CITY OF PORTSMOUTH, NEW HAMPSHIRE

ADDENDUM NO. 2

PRIMARY CLARIFIER AND GRAVITY THICKENER REPLACEMENT

BID NO. 03-15

SECTION 1
SCALE: 1/4"=1'-0"

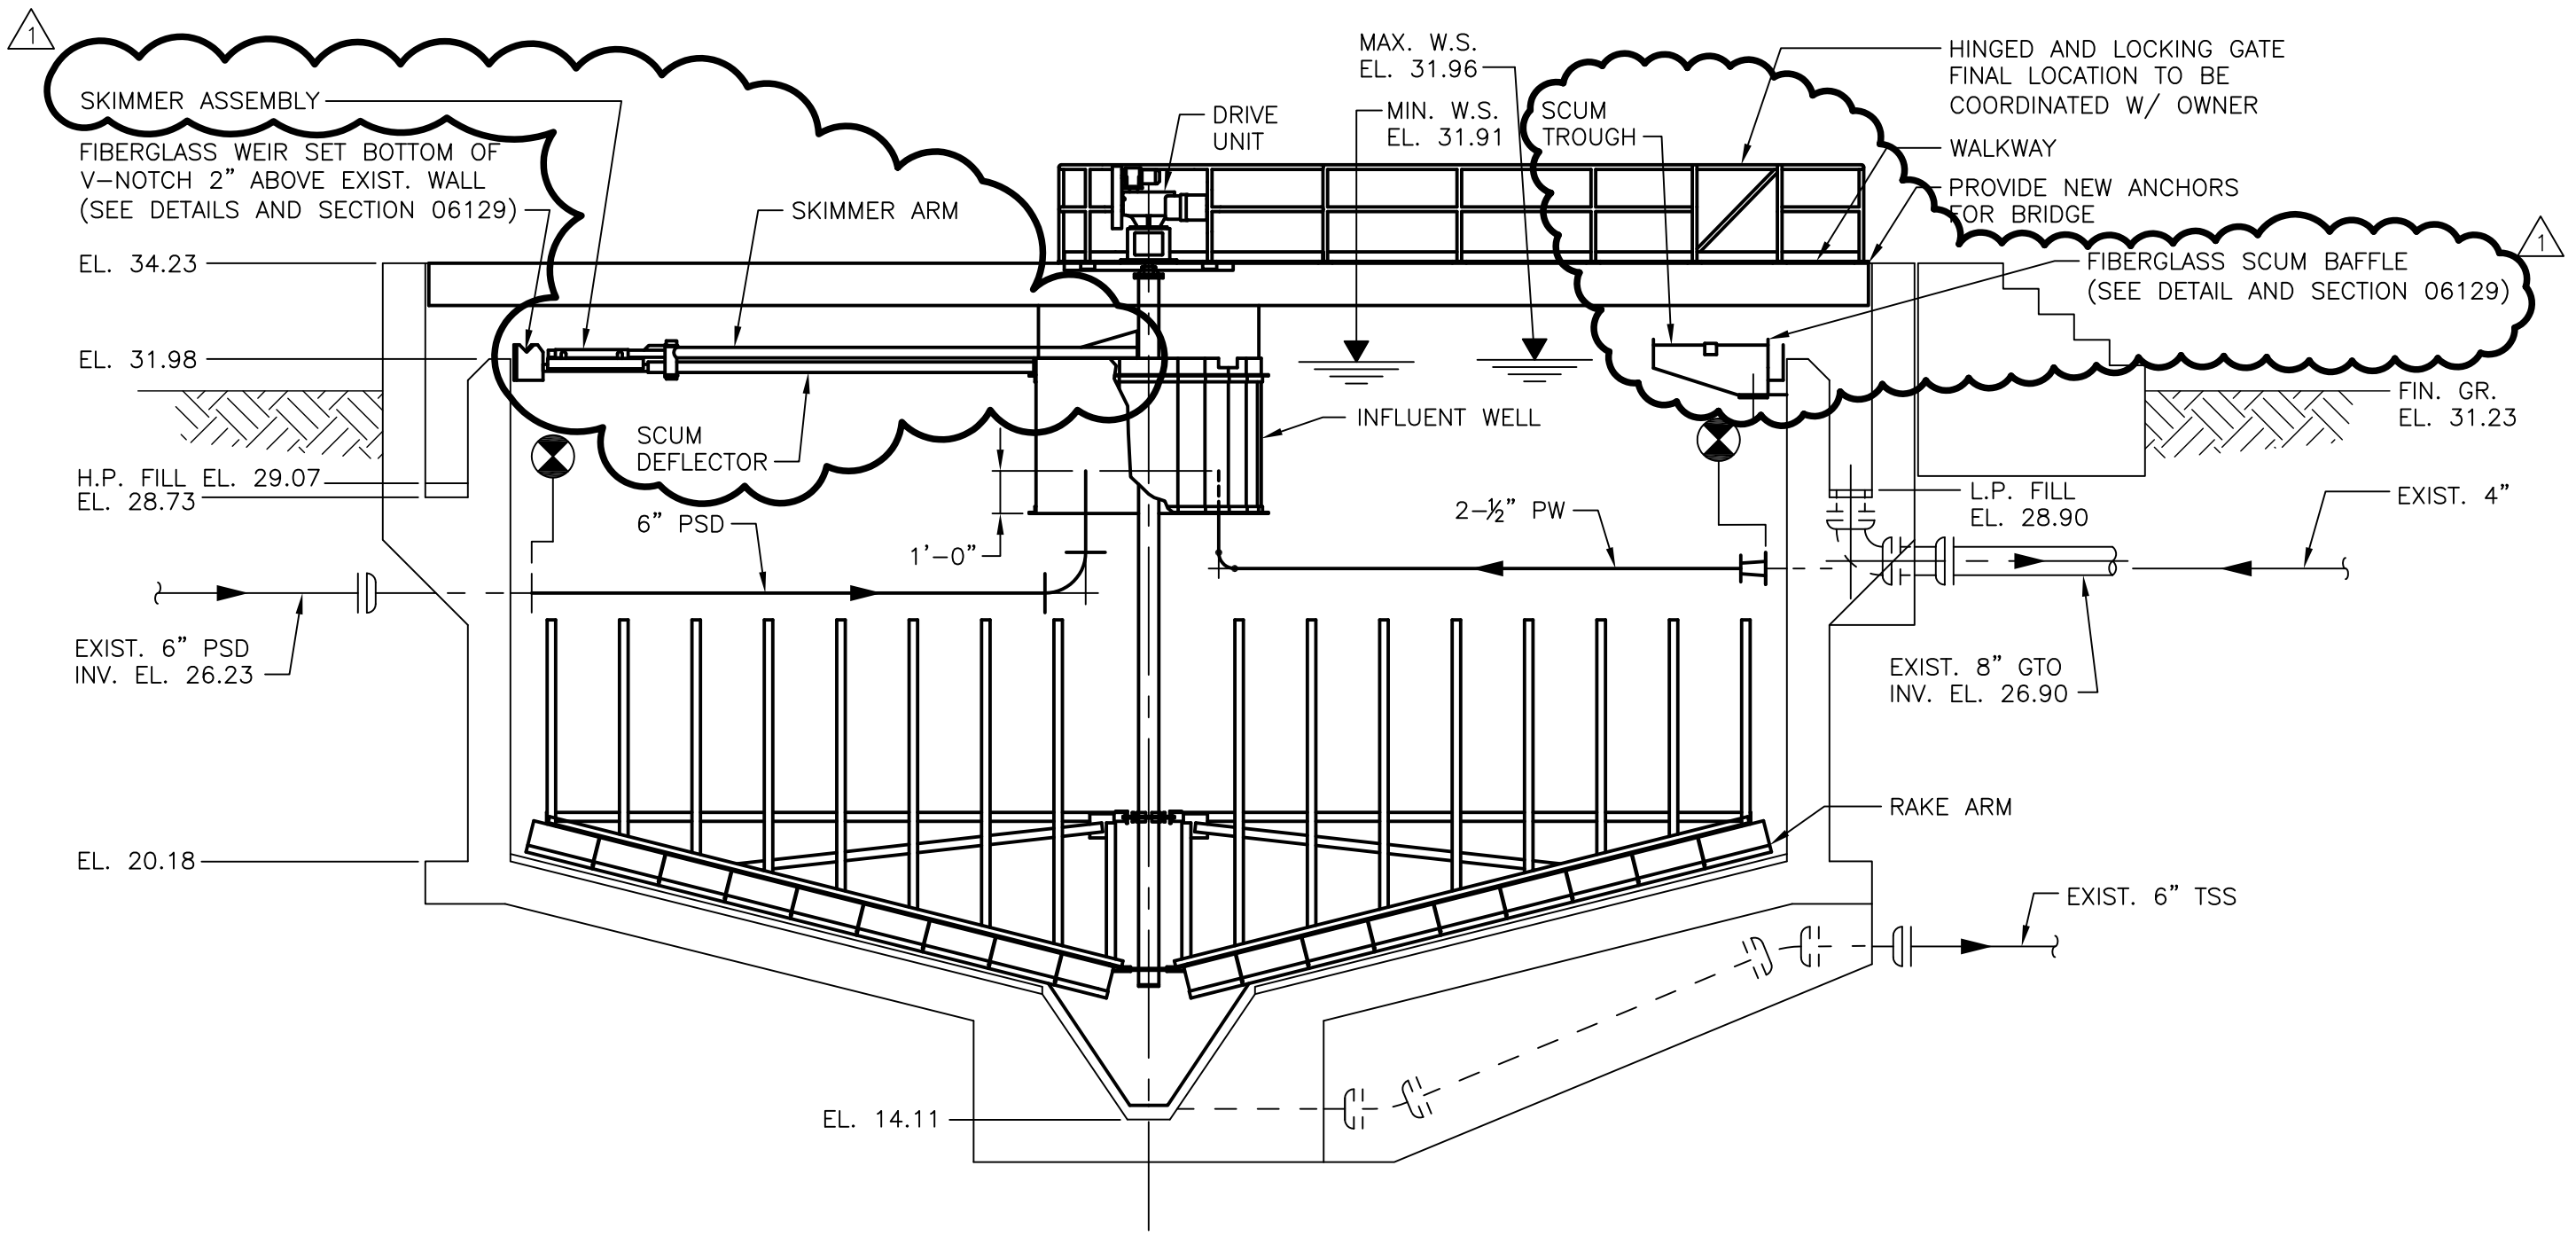
- 1. Delete Sheet No. 55 D-101 and replace it with the attached Sheet No. 55 D-101 dated July 14, 2014.

- NOTES:**
- SEE NOTE ON SHEET 55 DD-101 REGARDING REMOVAL OF EXISTING THICKENER DOME.
 - PROVIDE A SCUM SKIMMER, SCUM TROUGH, FIBERGLASS SCUM BAFFLE, 316 S.S. FASTENERS AND ANCHORS. TURN OVER TO THE OWNER IN ACCORDANCE WITH MANUFACTURER'S LONG TERM STORAGE REQUIREMENTS. THE SCUM SKIMMING SYSTEM TO BE INSTALLED UNDER BID PACKAGE 2.
